# CITY of BRISBANE

## Planning Commission Meeting Agenda

**B. PUBLIC HEARING: 3000-3500 Marina Boulevard; Design Permit Modification DP-1-21 (modification to DP-1-18);** SP-CRO Sierra Point Commercial District; Design Permit revision to modify the north and south elevations of Buildings 1 and 2 and the west and east elevations of Building 3 of the three-building biotech campus previously approved under DP-1-18 (2018); David Diamond, applicant; Bp3 Sf5 3000 3500 Marina LLC, owner.

**SUBJECT:** **3000-3500 Marina Boulevard; Design Permit DP-1-21;** SP-CRO Sierra Point Commercial District; Design Permit revision to modify the north and south elevations of Buildings 1 and 2 and the west and east elevations of Building 3 of the three-building biotech campus previously approved under DP-1-18; David Diamond, applicant; Bp3 Sf5 3000 3500 Marina LLC, owner.

Proposed Revision  
East elevation

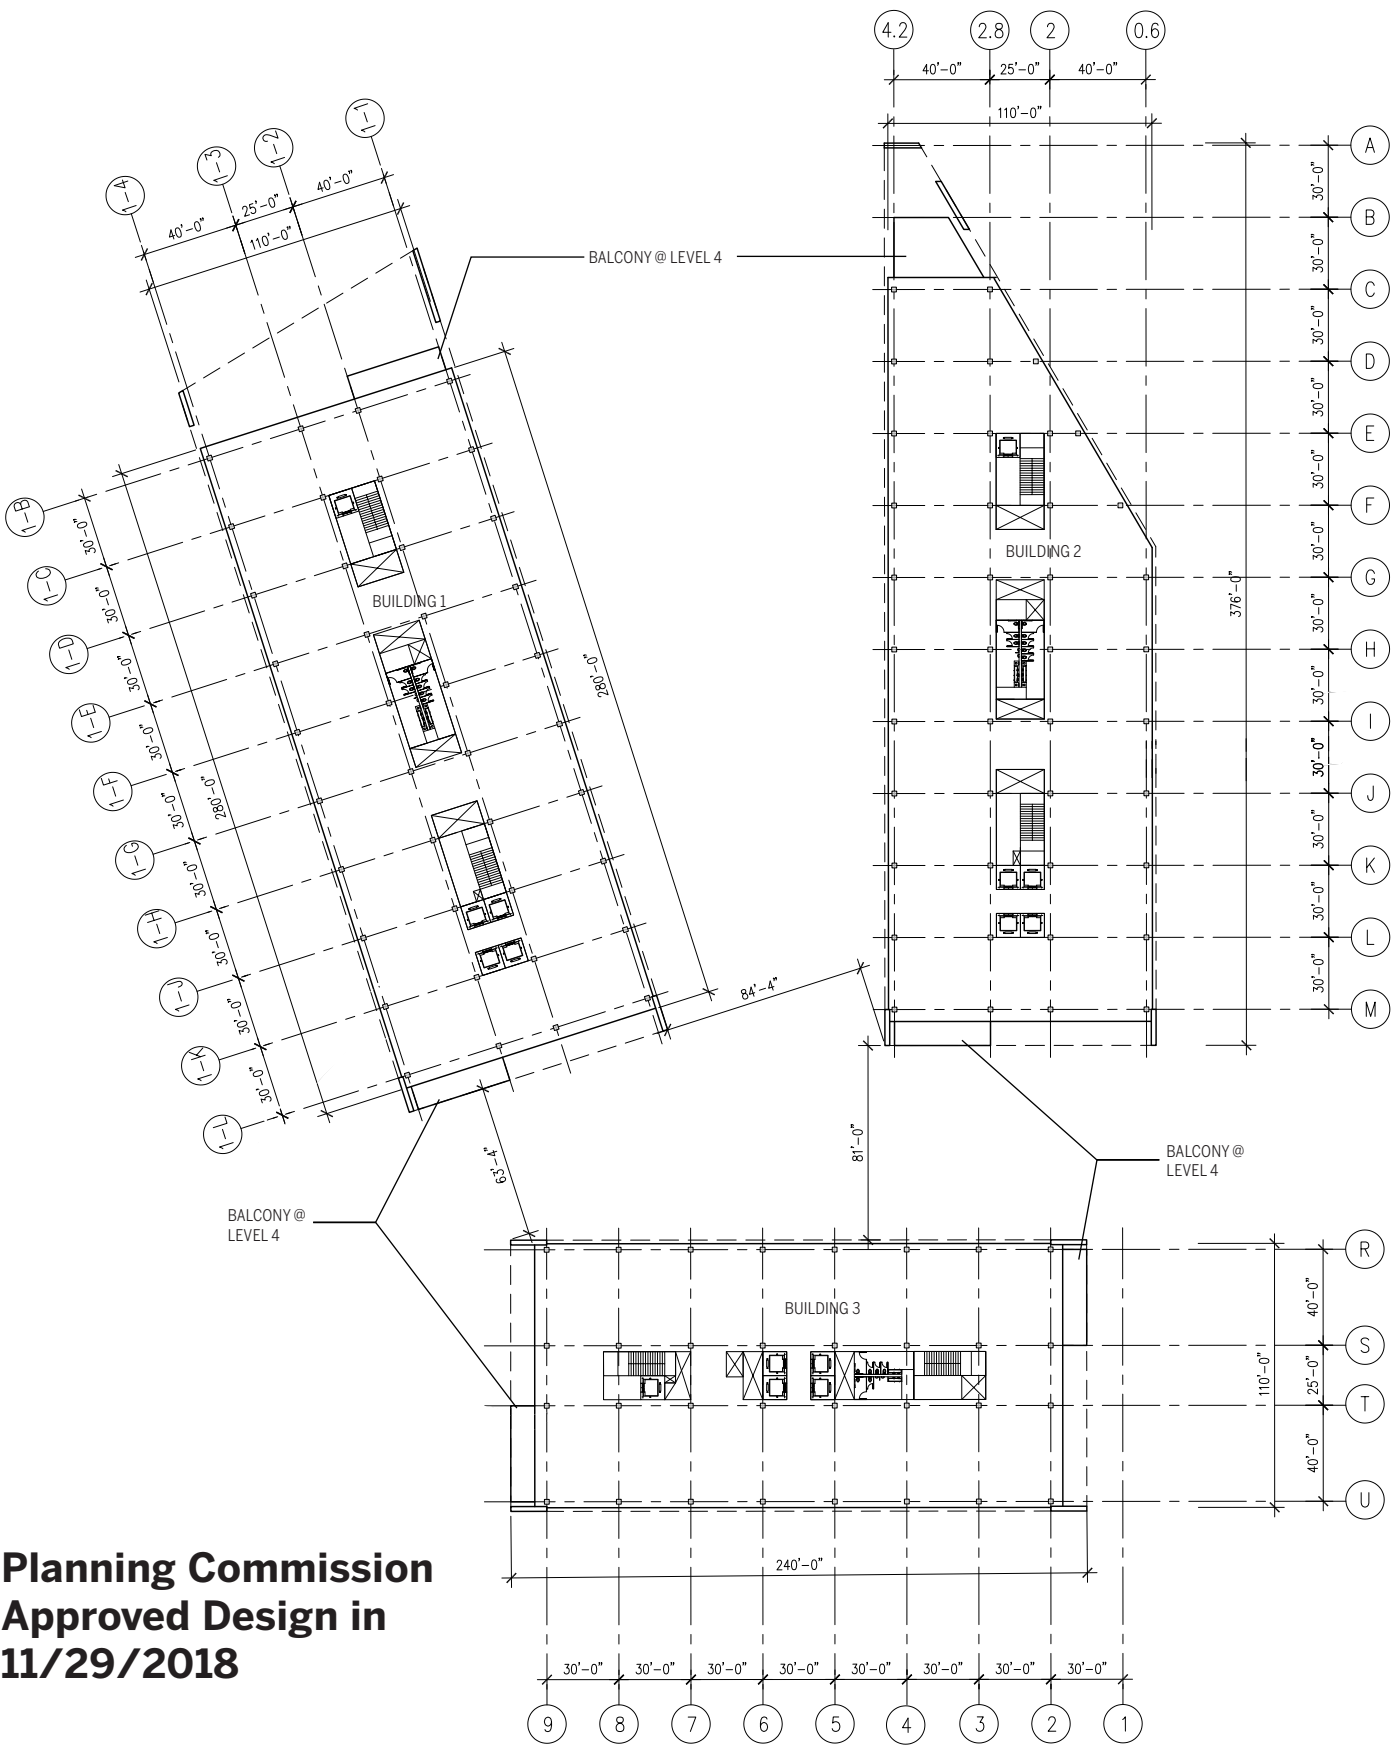
- Modify the dimensions and floor level locations of the cantilevered balconies on the north elevations of Building's 1 and 2 and west elevation of Building 3;
- Eliminate the balconies on the south elevations of Buildings 1 and 2 and east elevation of Building 3; and
- Reduce the dimensions and modify materials of the overhanging roof and side wall projections at the north and south elevations of Buildings 1 and 2 and west and east elevations of Building 3.

projecting balcony overhangs. The modifications to each building and to the projecting balcony overhangs are shown in the applicant's plans and renderings in Attachment B. The previously approved partial-floor width balconies at the north elevations of Buildings 1 and 2 and east elevation of Building 3 have been revised to covered and inset balconies that span the full width of the floor. The depth of the projecting balcony overhang on the north elevation of Building 1 has been reduced to a varying depth of 5-10 feet, and the depth of the overhang on its south elevation has been reduced to 5 feet. The depth of the projecting balcony overhang on the north elevation of Building 2 has been reduced to 15 feet, while the depth of the overhang on its south elevation has been reduced to 5 feet. The depth of the projecting balcony overhangs on both the west and east elevations of Building 3 have been reduced to 5 feet. The partial-floor width balconies on the south elevations of Buildings 1 and 2 and west elevation of Building 3 have been eliminated.

PROPOSED EXTERIOR ELEVATION - B1

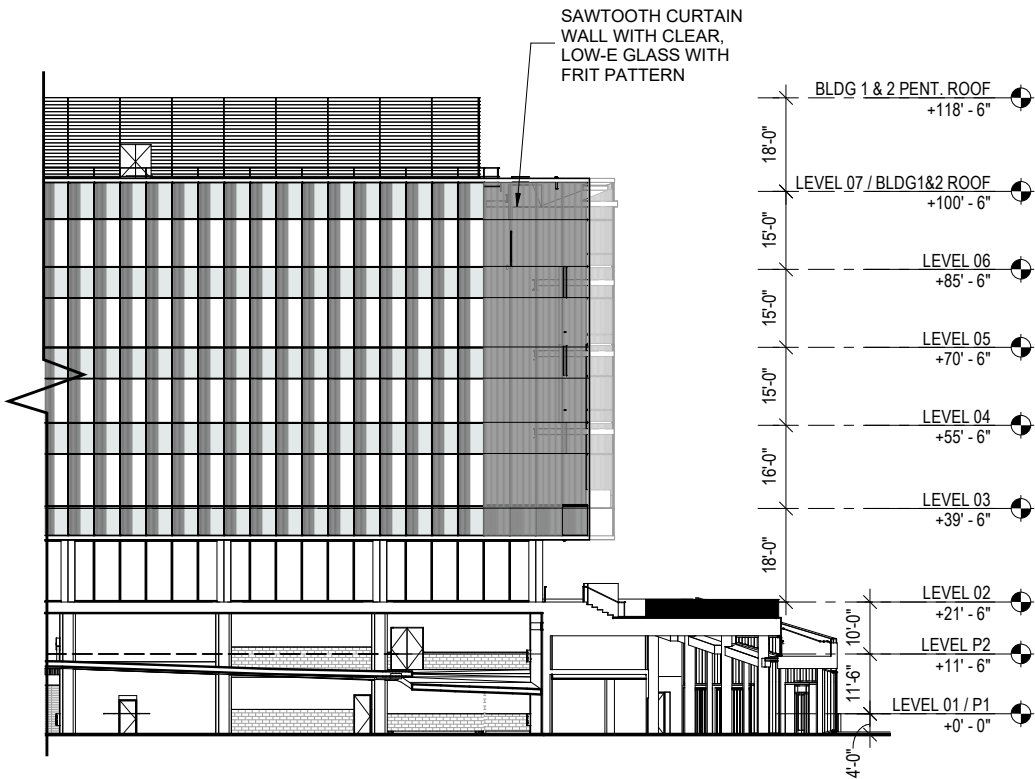
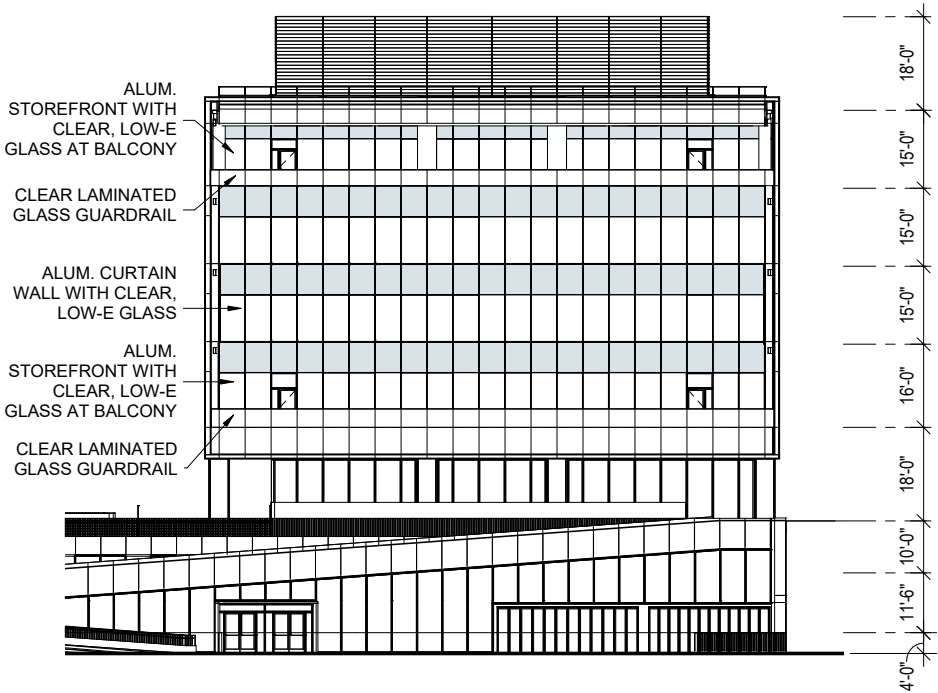
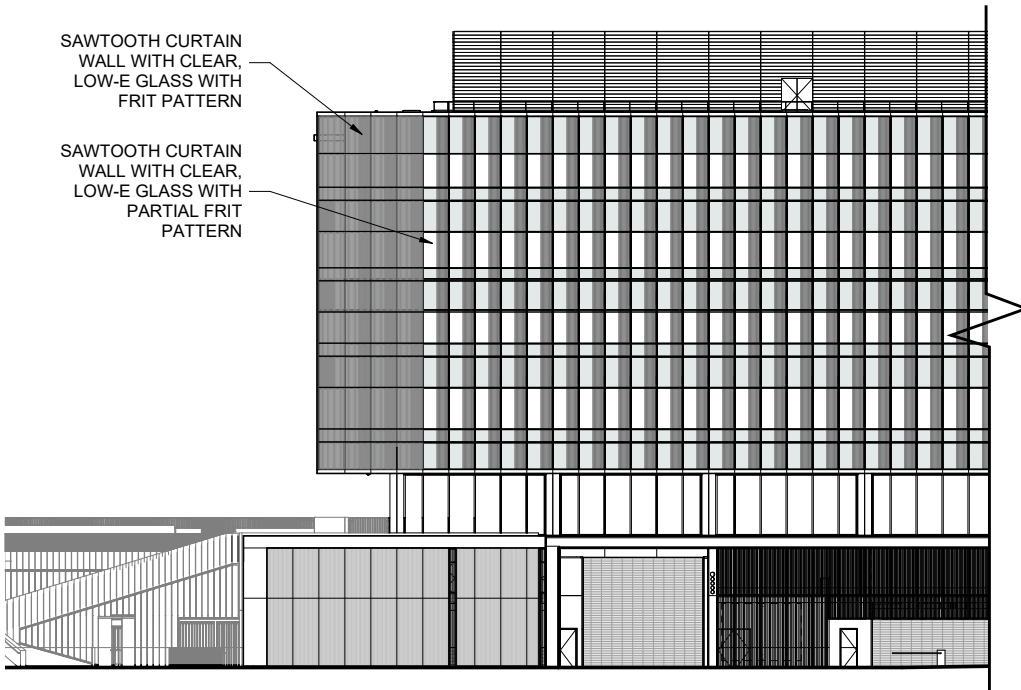
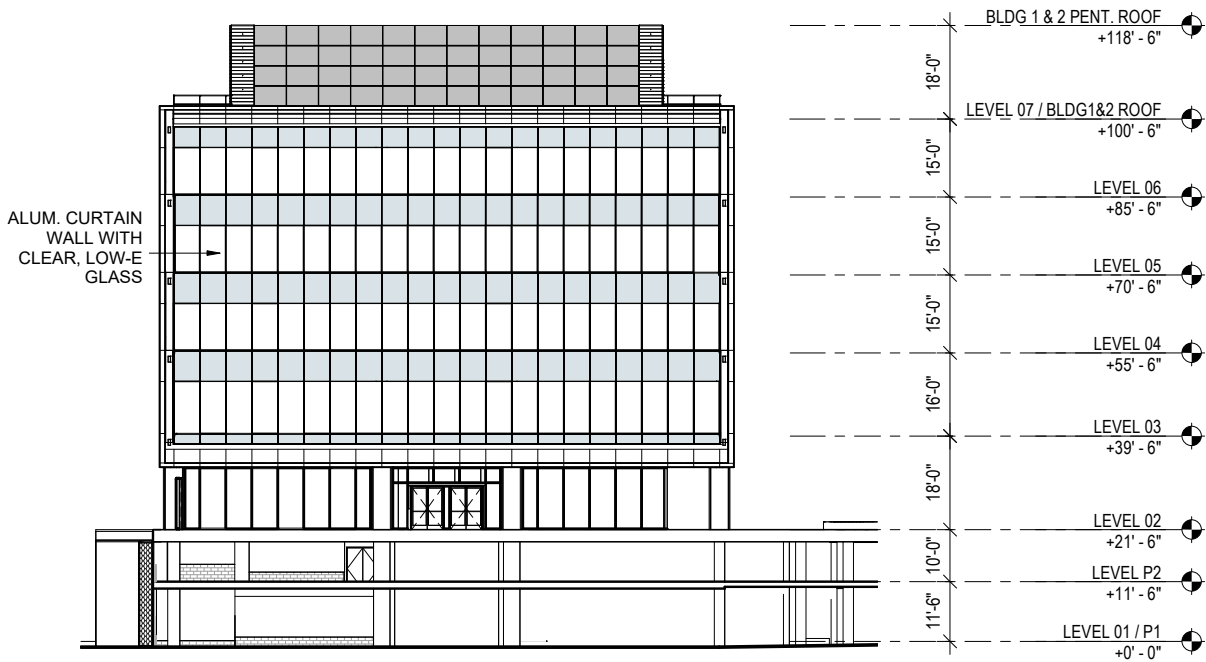
As noted above, the applicant proposes to modify the north and south elevations of Buildings 1 and 2 and the west and east elevations of Building 3 related to exterior balconies and associated

At all building end elevations, the applicant proposes modifying the materials of the decorative overhangs from perforated corrugated metal panels (approved in DP-1-18) to insulated fritted glass with aluminum framing within a sawtooth curtain wall. As described by the applicant, fritted glass is achieved by fusing opaque ceramic paint to the back side of the glass in a vertical line pattern. The frit improves the energy performance of the glass by providing some shading and reducing the solar heat gain in the interior of the building, and reduces glare on the exterior. The sawtooth curtain wall refers to the offset placement of the glass panes in a staggered fashion. Refer to Attachment B for the applicant's elevations with details showing the configuration of the sawtooth curtain wall.

PROPOSED EXTERIOR ENLARGED ELEVATION & PLAN

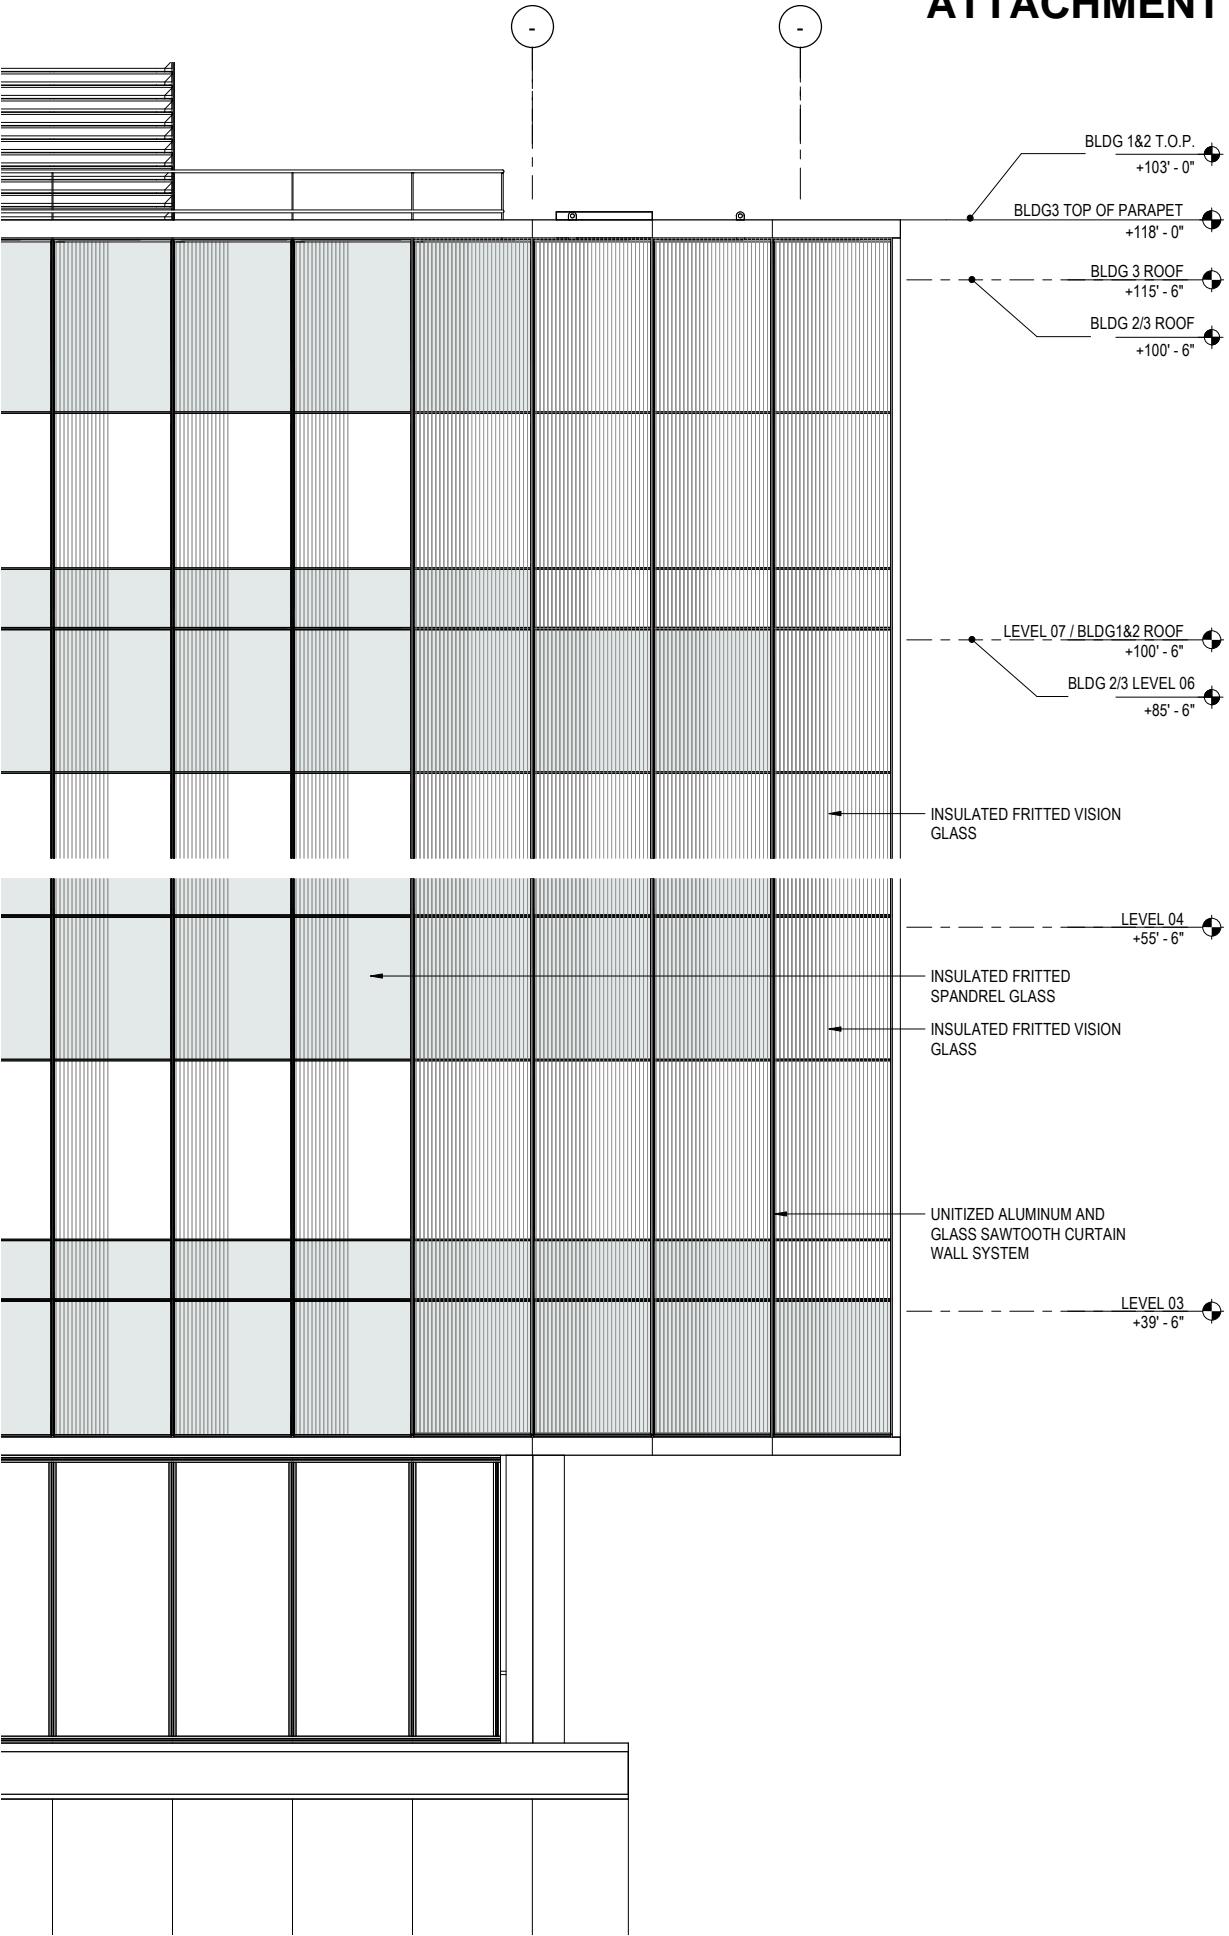
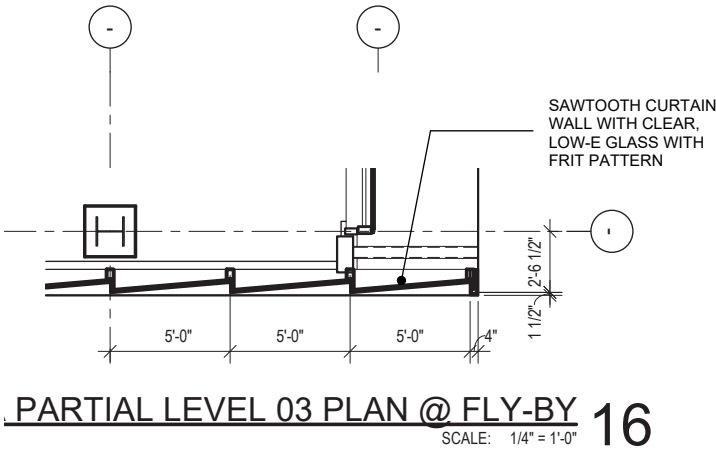
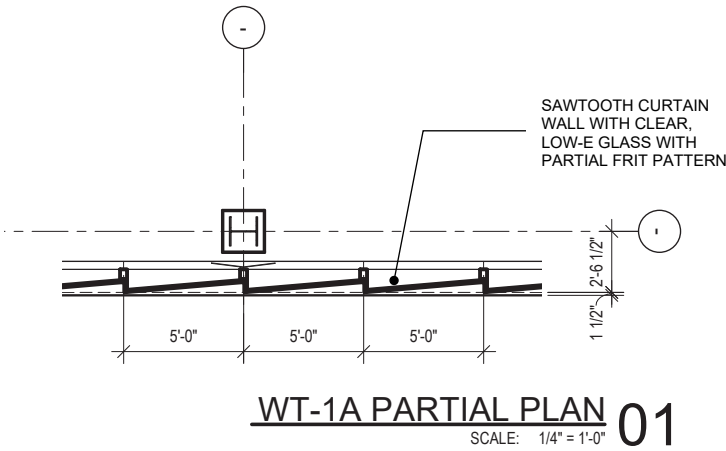
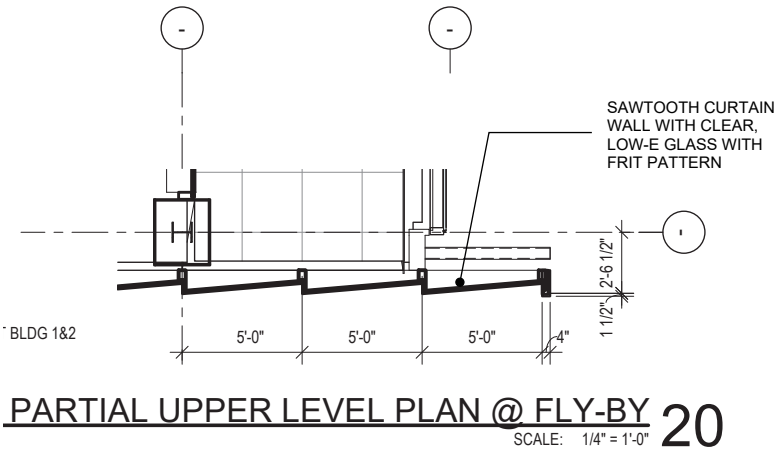
The materials on the side elevations at the projecting ends of Buildings 1, 2 and 3 were revised to a semi-transparent fritted glass sawtooth curtain wall panel system (from the originally-presented perforated metal panels).
